UNITED STATES PATENT AND TRADEMARK OFFICE

10/695,586

Office Action Summary

BARTIMUS, CHRISTOPHER
SHAWN

**Fig. 1**

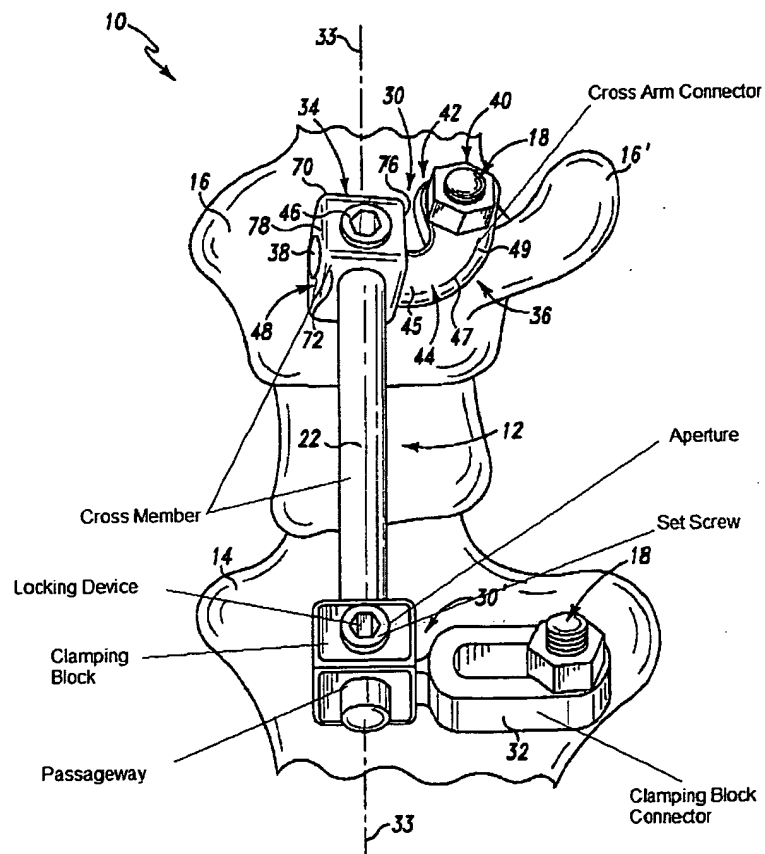
Krag discloses a multi-axial fixation device for use in aligning spinal members during operation, the device comprising: a clamping block (Fig. 1 below) the clamping block defining a passageway (Fig. 1 below), the passageway configured to receive a cross member therein, the clamping block having a clamping block connector (Fig. 1 below) connected thereto, and the clamping block connector is capable of connection with a first spinal member.

The cross member is capable of insertion within the passageway (Fig. 1 below), the cross member having a cross arm connector (Fig. 1 below) connected thereto, the cross arm connector configured to connect with a second spinal member, the cross member configured for variable locked positioning within the clamping block by a locking device (Fig. 1 below); the locking device is capable of allowing the cross member to be variously adjustably positioned and held within the clamping block; the clamping block, the locking device and the

cross member are capable of allowing variable positioning and locking of the cross member thereby allowing multiple adjustable positioning of the spinal members. The locking device comprises a plurality of stacked portions (the portions of the cross member, the set screw, and the clamping block involved in locking the device, Fig. 1) that are configured to lock and hold the cross member by compressive force upon the stacked portions. The passageway is a transverse multi-positional opening through the clamping block. The passageway extends through the clamping block and the cross member can be swiveled in the passageway and can be locked in a variety of positions, hence the passageway is a transverse, multi-positional opening through the clamping block. A cross arm connector and the clamping block connector are each capable of connecting with a spinal member through the use of a pedicle screw (Fig. 1). The cross member connector further comprises a safety stop (Fig. 7 below); the safety stop is capable of preventing withdrawal of the cross member from the passageway. The locking device is multiply adjustable through the use of a set screw (Fig. 1 below). The clamping block further defines an aperture (Fig. 1 below) configured to maintain and hold the set screw within the clamping block. The clamping block is configured to have a flat surface with rounded edges (Fig. 2) and is capable of preventing discomfort that may be experienced by the recipient. The clamping block is configured to define at least one access opening, the access opening capable of allowing the passage of body fluids around the clamping block. The access opening can be considered to be the aperture through which the clamping block connector is connected to the clamping block

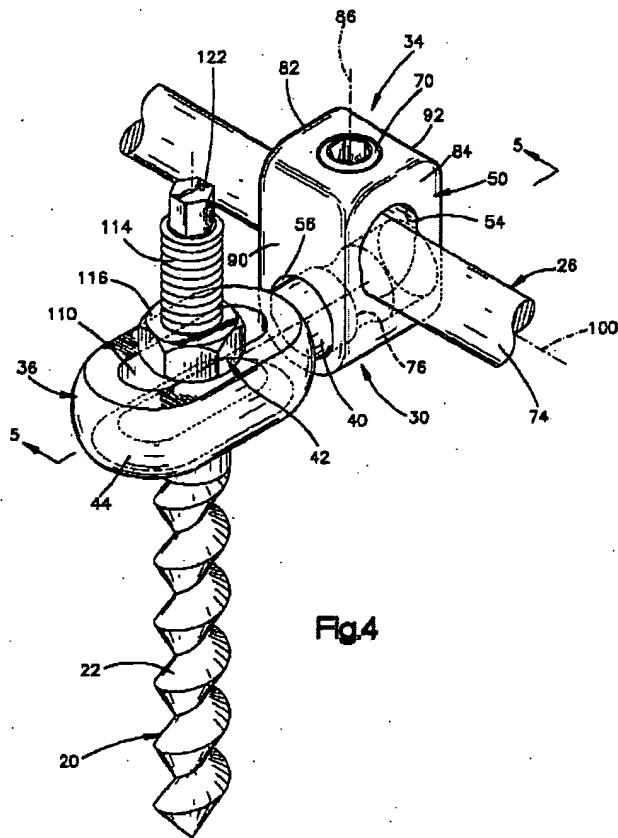
(as seen in Fig. 4 below, ref. 56 from US Pat. 5,741,255, incorporated by reference in column 2, lines 41-43). The device further comprises a retaining clip, the retaining clip configured to allow the locking device to be retained and removed from within the clamping block. The retaining clip can be considered to be the thread of the set screw (Fig. 1 below). The cross member passes through the passageway (Fig. 1) and the locking device is capable of allowing variable linear, rotational, and angular positioning of the cross member. The angles and location of the cross member connector and the clamping block connector are capable of being used in series and combination for use in multiple level fusions and bridging. The locking device is capable of postoperative access by a non-invasive means to accomplish a variety of postoperative adjustments. The device is capable of allowing selective disengagement and adjustment of the spinal members in one direction while retaining the spinal members in a secured position in a second direction.

since it can rotate and slide in its respective aperture (Fig. 4 above from US Pat. 5,741,255, incorporated by reference in column 2, lines 41-43); the clamping block, the locking device and the cross member are configured to allow variable positioning and locking of the cross member thereby allowing multiple adjustable positioning of the spinal members, since the cross member can slide in the clamping block when not in a locked position (Fig. 4 above from US Pat. 5,741,255, incorporated by reference in column 2, lines 41-43); affixing pedicle screws or anchoring device as presently used in the field to each side of the disk space to be bridged (Fig. 1 above), attaching the embodied mechanism on the threaded pedicle screws with nuts (Fig. 1 above); aligning the spine across the affected disk space to be anatomically correct (column 2, lines 15-16) and tightening the set screw (column 3, lines 14-19); and making adjustments postoperatively by a non-invasive procedure if necessary (column 6, lines 8-11).

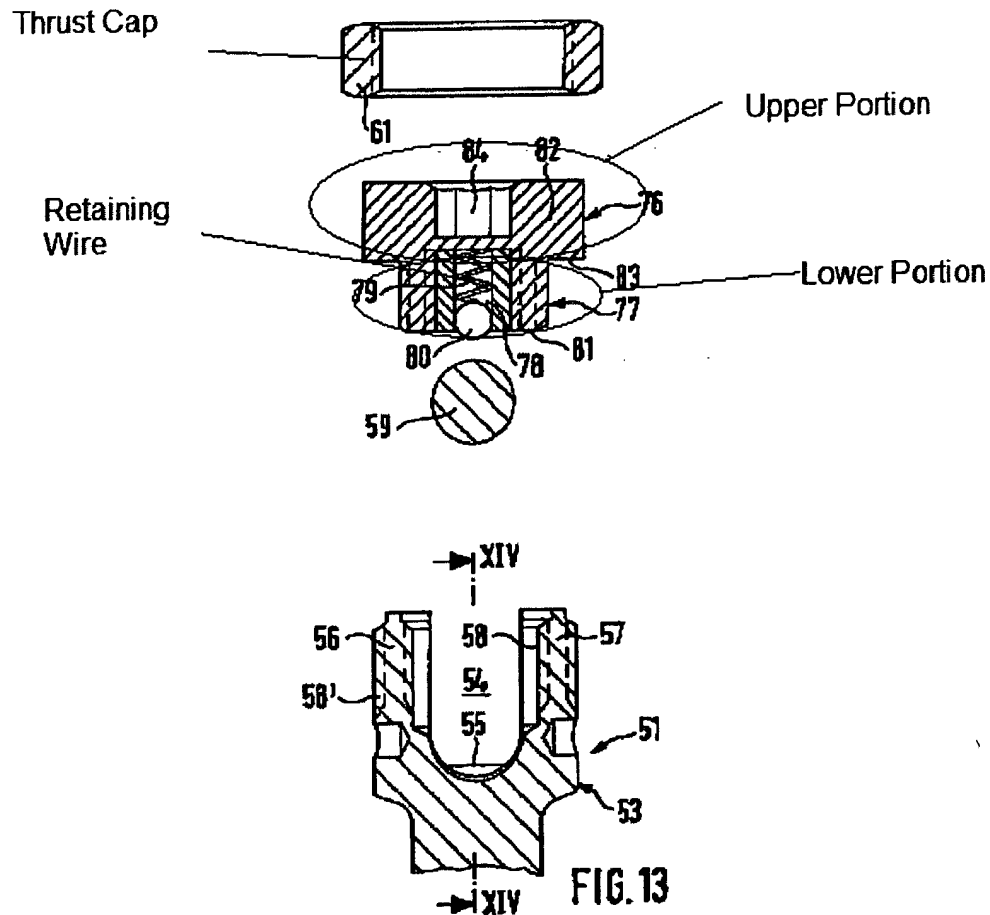
Biederman et al. disclose: a thrust cap (Fig. 13 below), an upper portion (Fig. 13 below) and a lower portion (Fig. 13 below), the thrust cap the upper portion and the lower portion each having a radius configured to interact with an adjoining portion when placed in a desired position and orientation, the upper portion and the lower portion each having a radius center and configured so that the radius centers are offset when the upper portion and the lower portion are placed in correct alignment within the clamping block. The thrust cap is held in position by a retaining wire (Fig. 13 below) configured to retain the thrust cap from sliding out of the clamping block and preventing the whole system from disassembling when in a loosened state. The thrust cap, upper portion and lower portions are used in order to obtain a rigid connection between the anchoring member and the rod and also to allow an easy manipulation for precisely
